Replacement of Windows and Doors to Impact Rated Material at Various City Parks

Invitation for Bids # RE-24-05

THE CITY OF PEMBROKE PINES
PROCUREMENT DEPARTMENT
8300 SOUTH PALM DRIVE
PEMBROKE PINES, FLORIDA 33025
(954) 518-9020

A-101

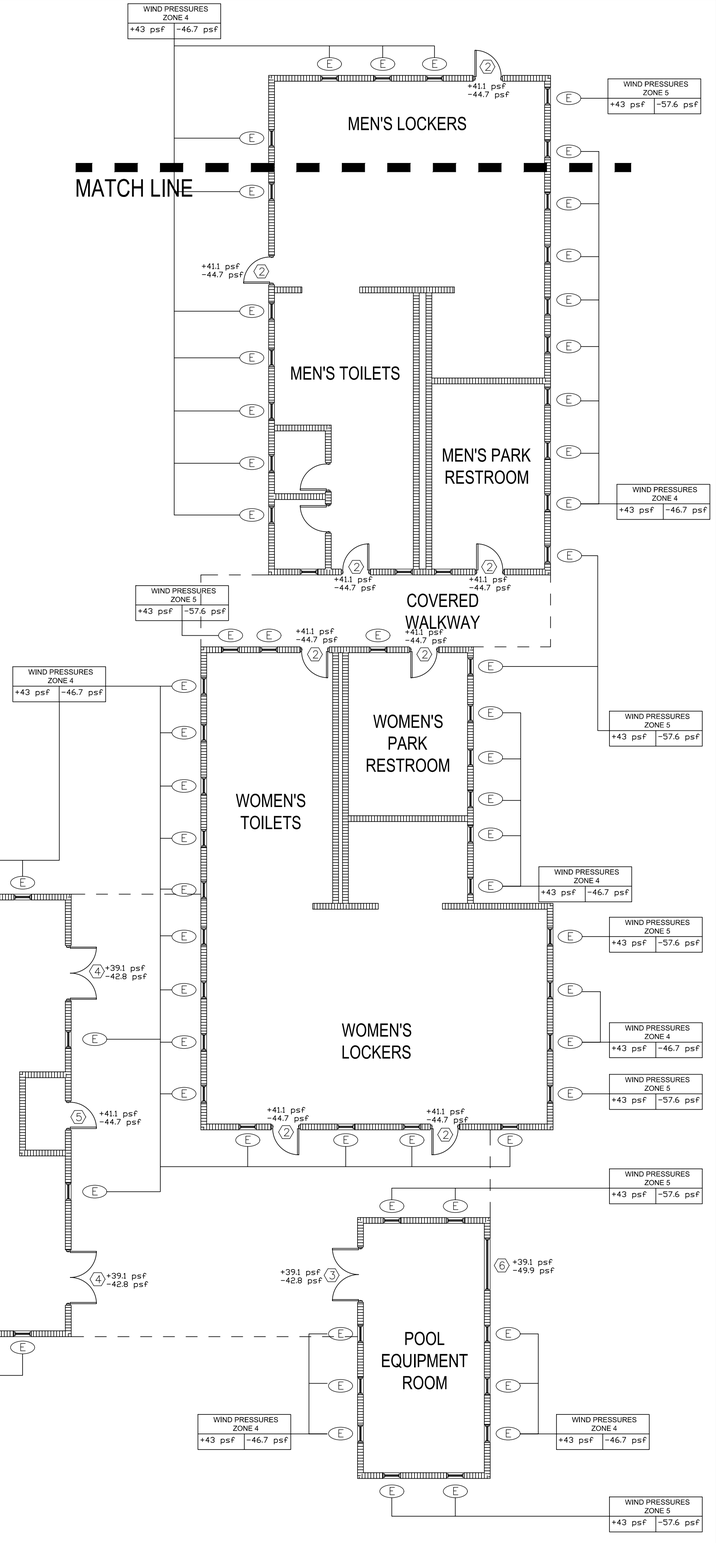
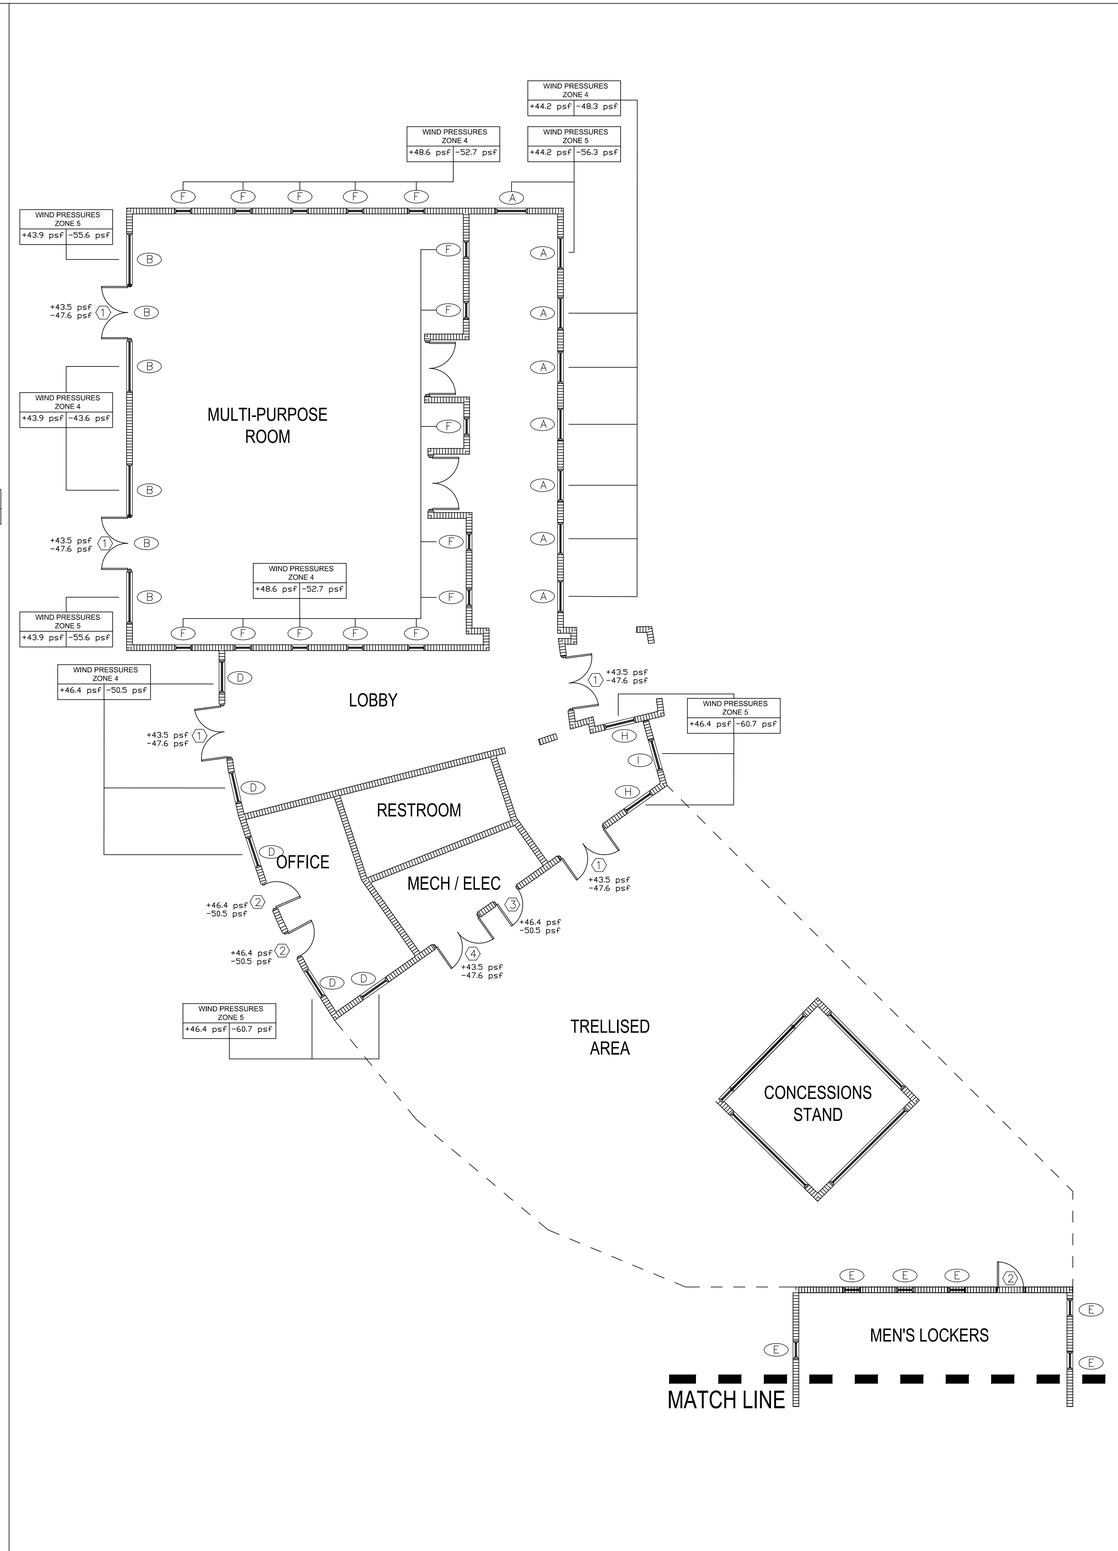
15. Page 2 Attachment 6. Drawing A-101 PINES PINES RECREATION PARK - BCC BUILDING WINDOW AND DOOR RETROFIT, louvers are drawn and dimensioned on the south and north facades, but not in plan. Please confirm if the louvers are within the scope of work.
